North Dakota Department of Transportation

ADDENDUM 2 – JOB 15

TO: All prospective bidders on project NH-1-200(073)236 and NH-1-003(048)134, Job No. 15 scheduled for the November 17, 2017 bid opening.

ND 200, Jct 14 E to W Jct 3

Plan & Profile
Sta 12694+00 to Sta 12714+00

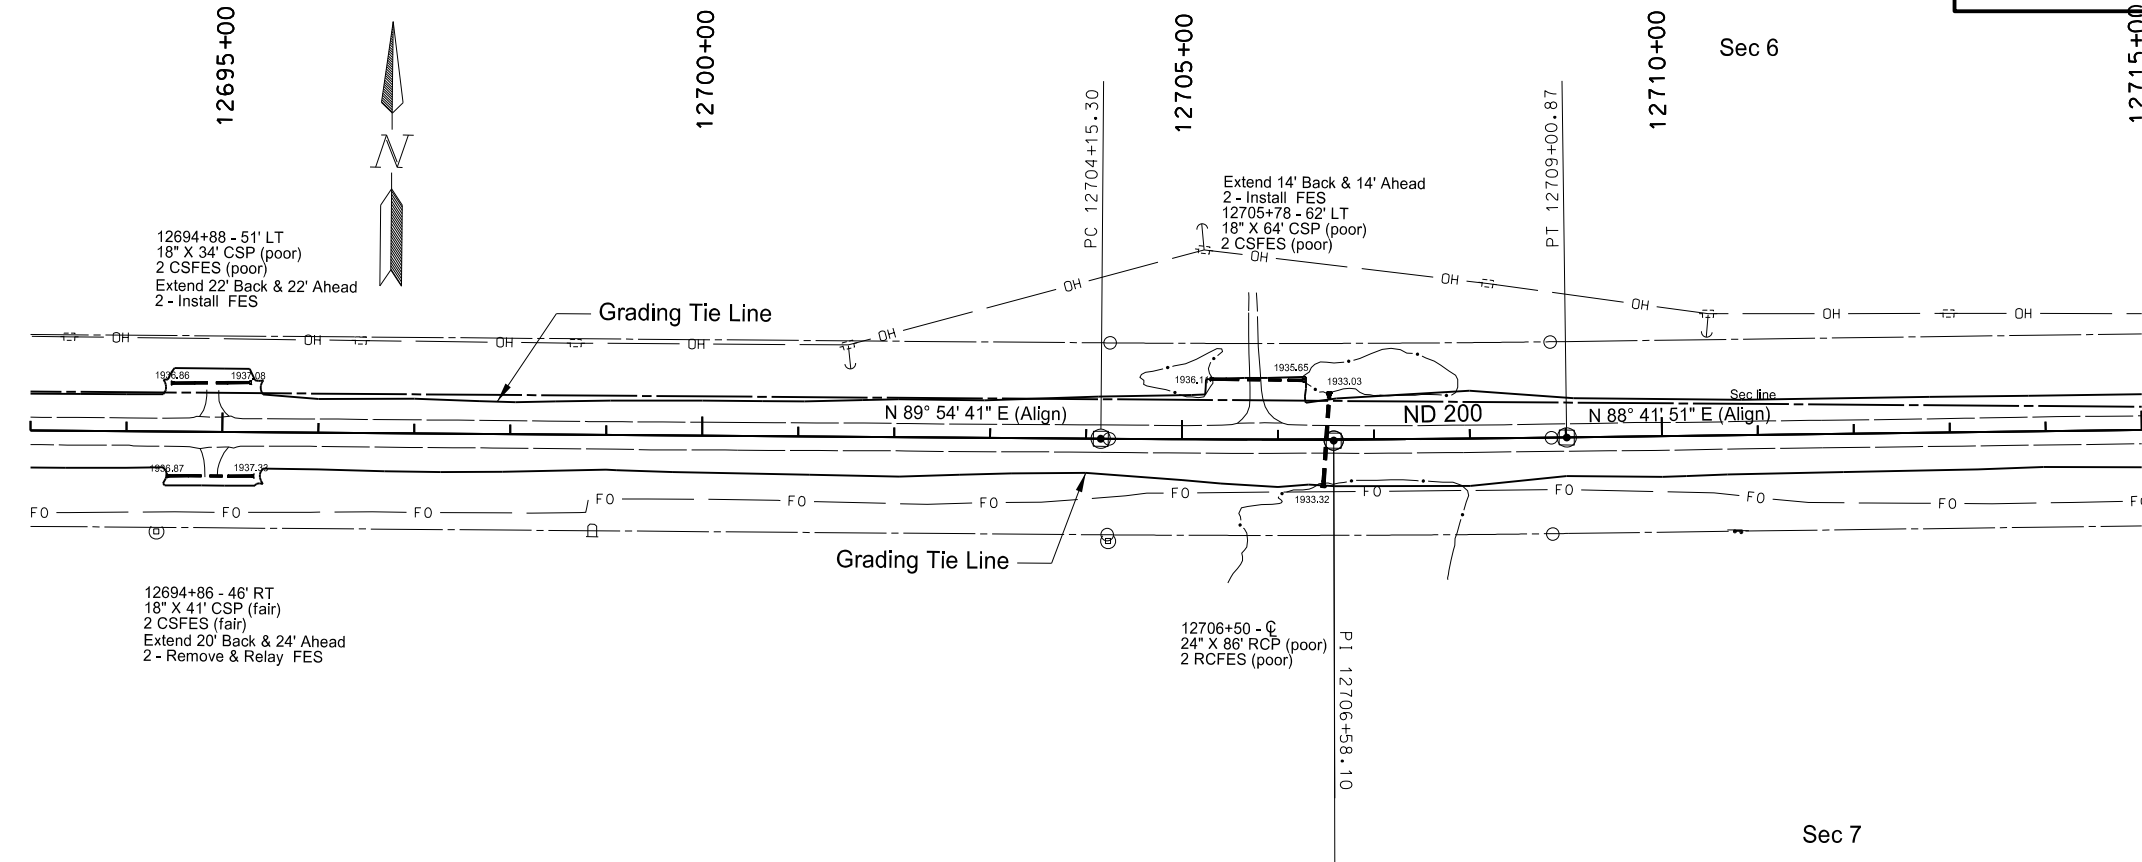
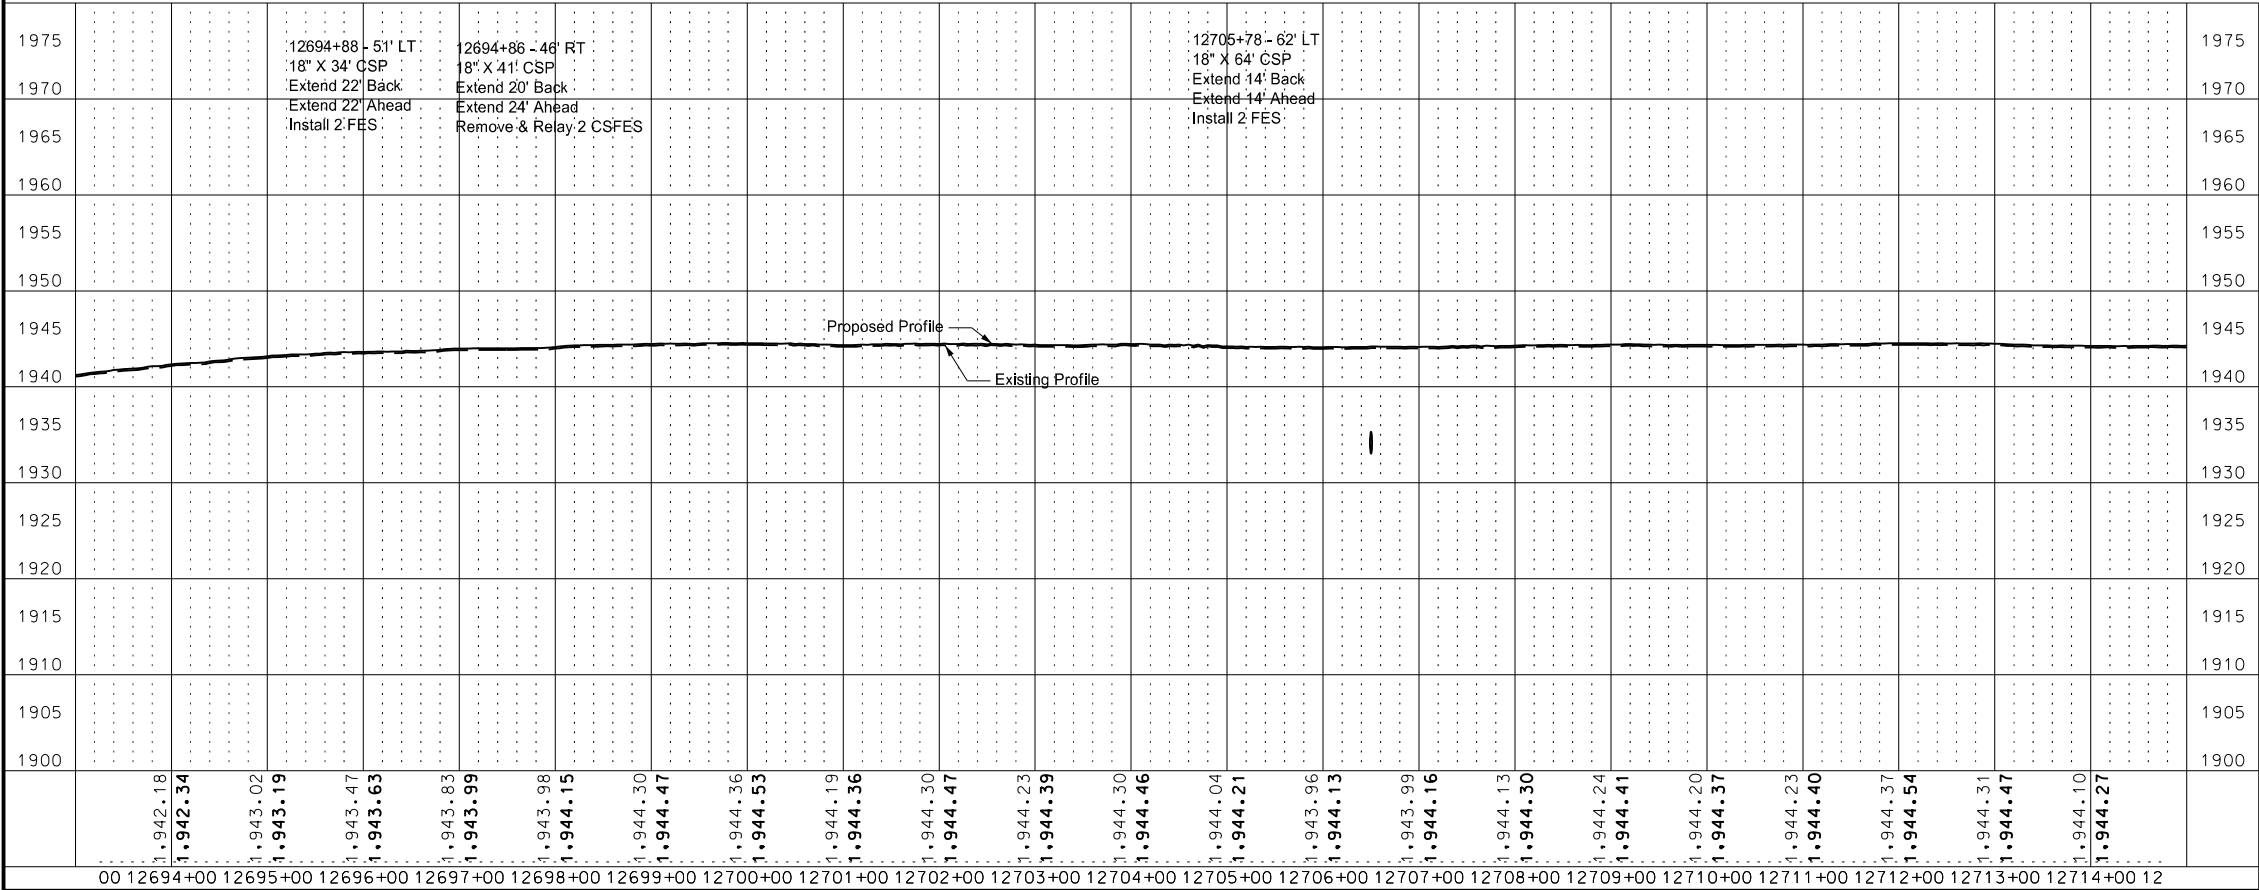
Section 60 Sheets 6, 11, 12, 15, 18, 20, 22, 23, 24, 26, 27, 28, 29, 30, 31, 34, 35, 37, 38, and 40:

Updated pipe information and quantities. Item 714 5820 was added on sheet 38.

Plan & Profile
Sta 7190+00 to Sta 7195+47.84

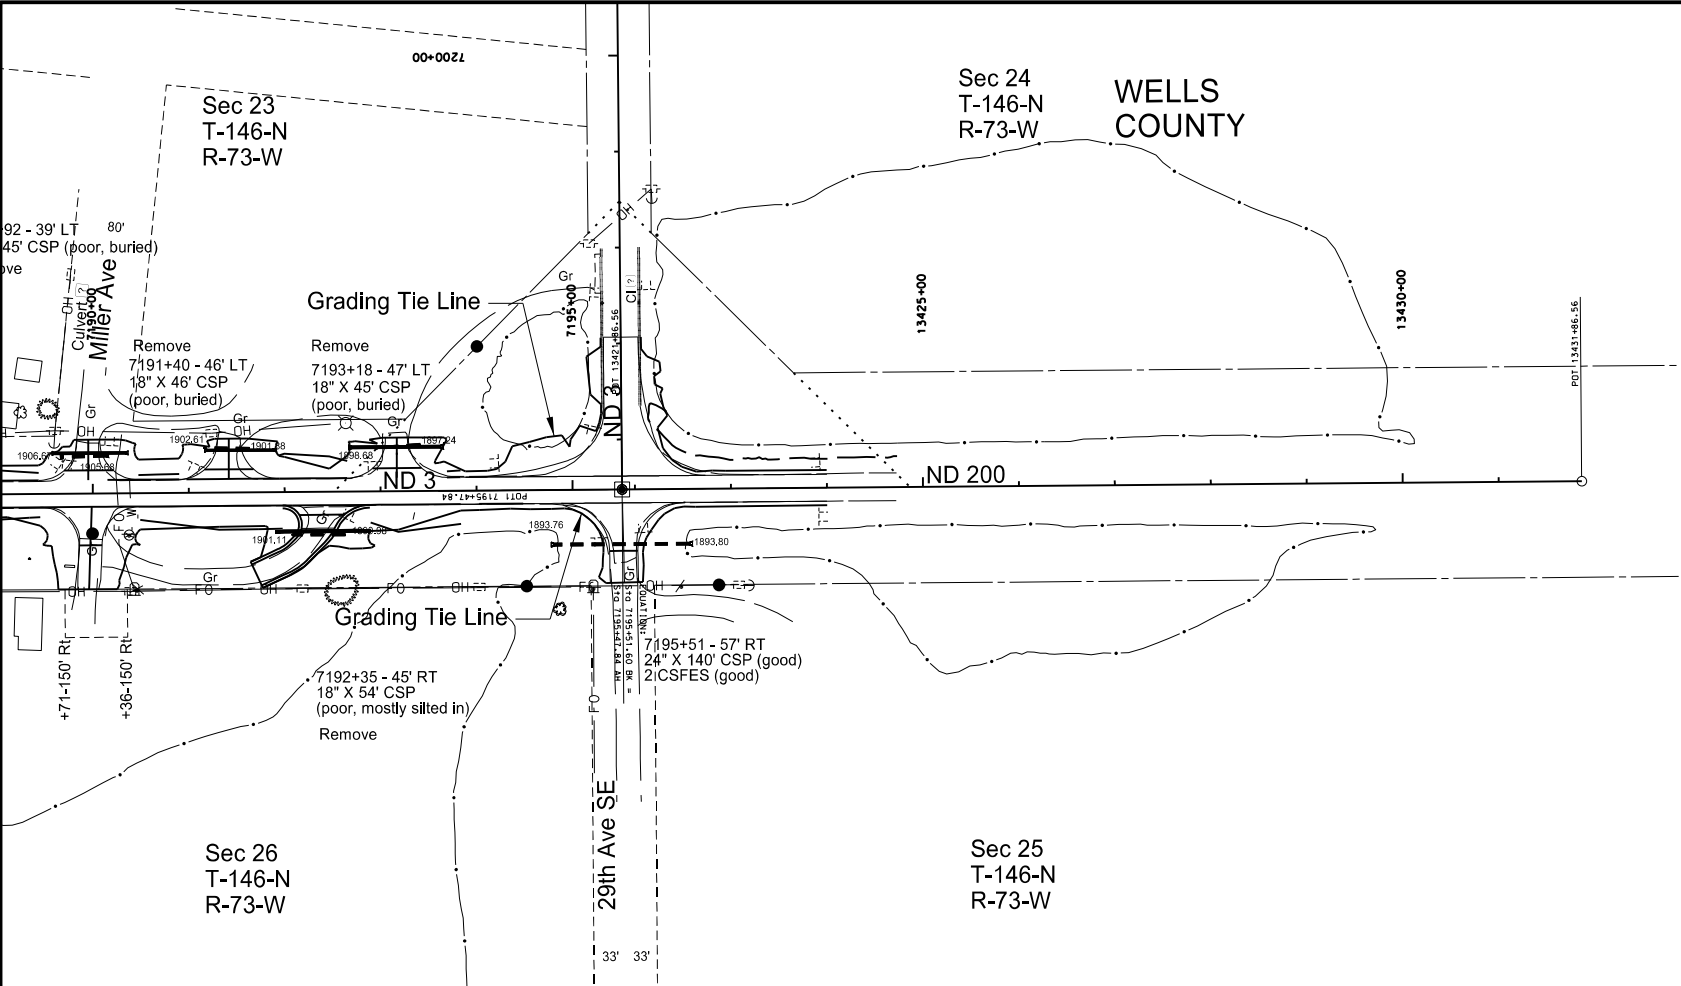
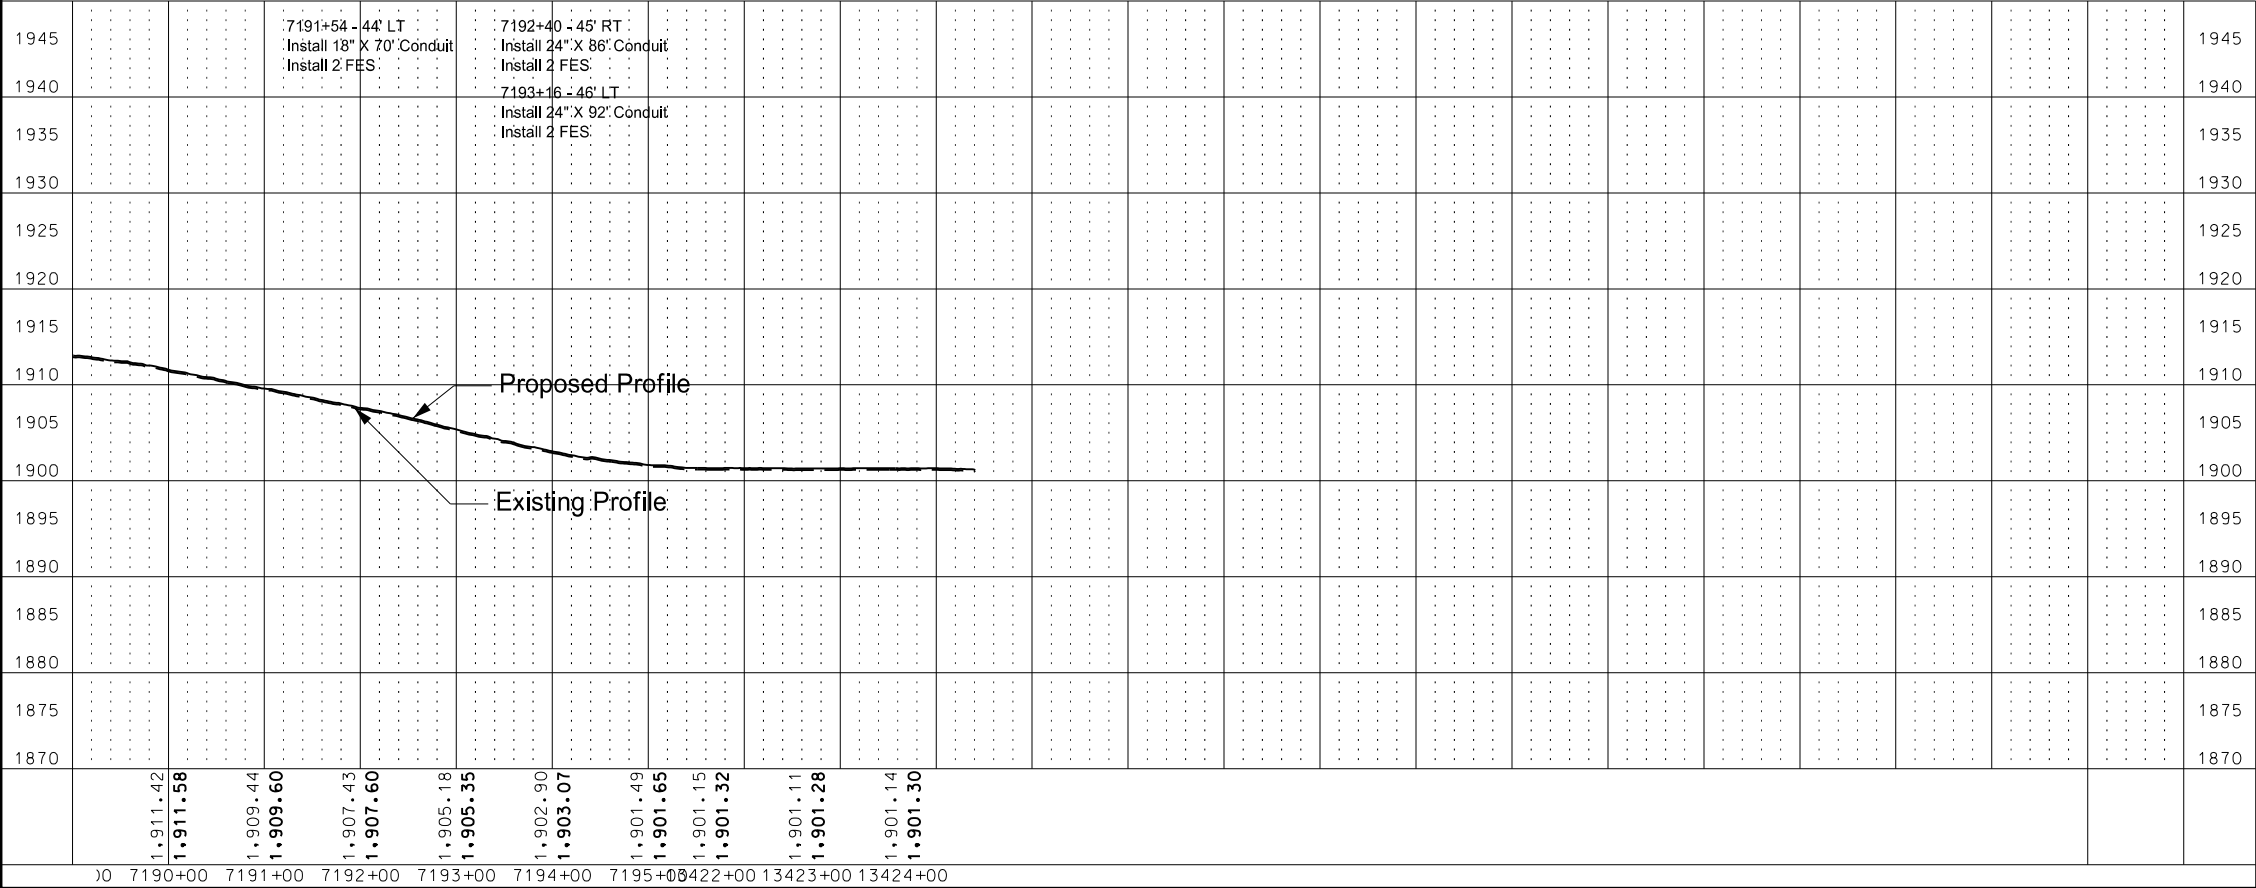
Section 60 Sheets 2, 5, and 6:

Updated pipe information and quantities
